2014-10-12

Replace Clutch Master Cylinder Piston Assembly

Figure 1. Recall Kit 91500068

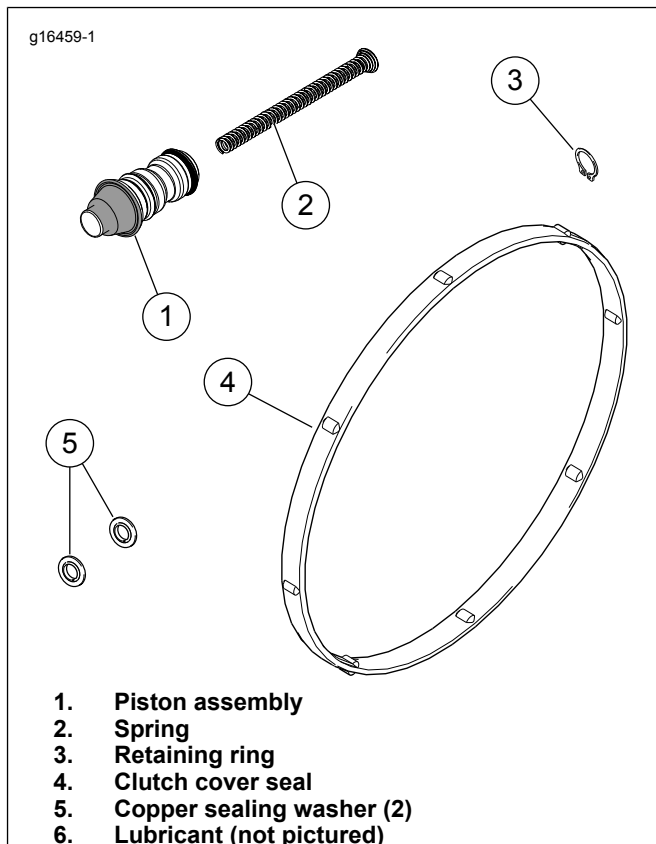
1. Confirm that the motorcycle is involved in Recall 0159. If the status includes an **open** for Safety Recall 0153, the 0159 should be performed and the 0153 will be closed by HDMC once the 0159 claim is approved.
2. Obtain the recall kit (Part No. 91500068).
3. Replace the clutch master cylinder piston assembly with parts from the recall kit. This kit is to be used on both original equipment clutch master cylinders and chrome accessory clutch master cylinders (Part No. 41700263 and 41700263A). See CLUTCH MASTER CYLINDER AND RESERVOIR in the service manual.
4. Fill and bleed clutch fluid system. See the service manual.
